TECHNICAL MEMORANDUM

TO: Rachael Brown, City of Puyallup
FROM: Lisa Palazzi, CPSS, PWS, SCJ Alliance
DATE: March 10, 2020
PROJECT #: 727.07, Task 20: P 19-0074 Kessler Center
SUBJECT: Sitts and Hill SW report: Potential impact on SW Wetland

Figure 3. Adapted from S&H Report Figure 5 – Wetland Basin Area.

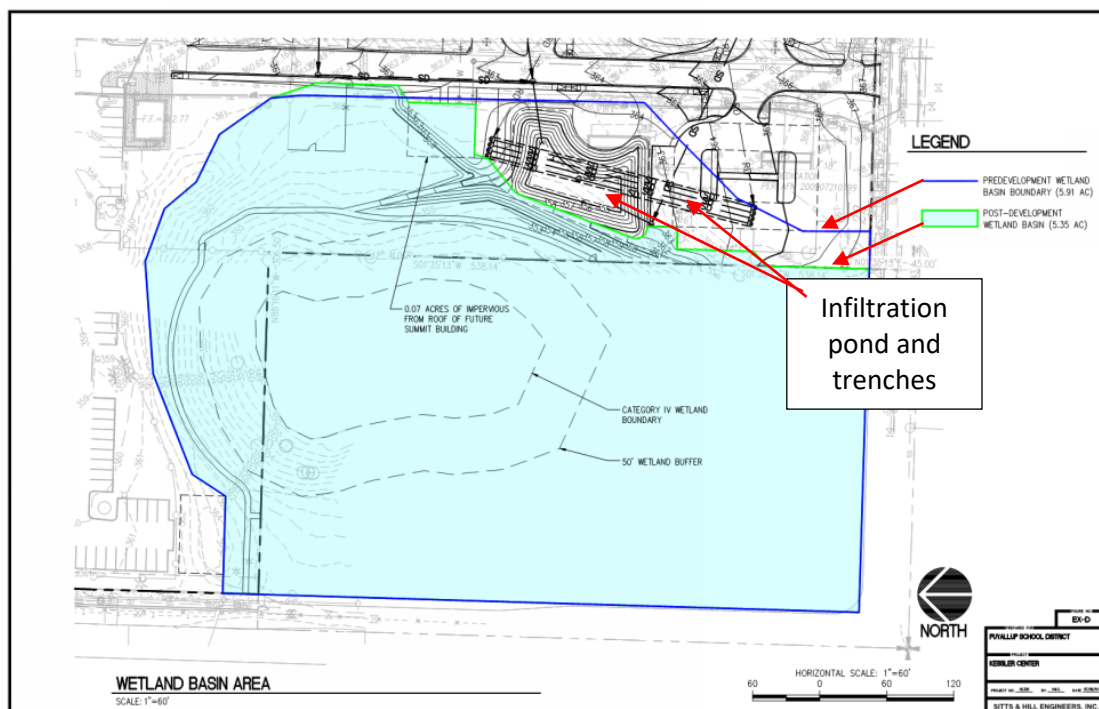
Figure 5 in the S&H report (adapted and provided below in Figure 3) indicates that a portion of the pre-development basin for the Southwest Wetland will be used for an infiltration facility – changing the predeveloped pervious surface area from 5.91 acres to 5.28 acres. Appendix D indicates that 0.07 acres will be converted to impervious “roof surface”, and Figure 3 below shows that an infiltration facility will be sited in the southeast upslope edge of the kettle basin.

However, most relatively undeveloped kettles like this one are mostly groundwater-fed, and under current conditions, surface flow contributions in the highly permeable pre-developed condition are not expected to be significant in any case. Therefore, this change in surface conditions in combination with addition of an infiltration facility southeast of the kettle wetland is not expected to have a significant impact on the wetland hydroperiod. The water infiltrated in this design would most likely have infiltrated in the predeveloped condition, and thus would drain to groundwater, and then to the wetland within about the same annual time period.

This expectation is supported by modeling results provided in Appendix D, which indicate that the wetland hydrology will after development will be within 10% of the predeveloped condition – considered to be an acceptable variation in hydroperiod.
